UNITED STATES ENVIRONMENTAL PROTECTION AGENCY

Subject: November 2nd and 3rd, 2022, EPA Inspections

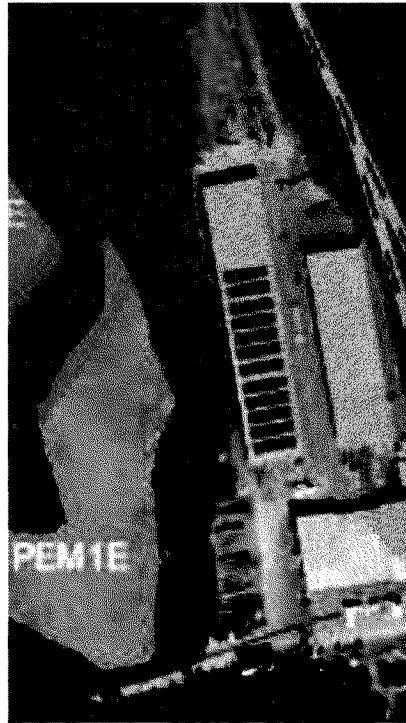
5. Draw the outline of the northwestern and southwestern detention pond as well as the flow path between the two ponds on the image below (which portrays nationally defined wetlands).
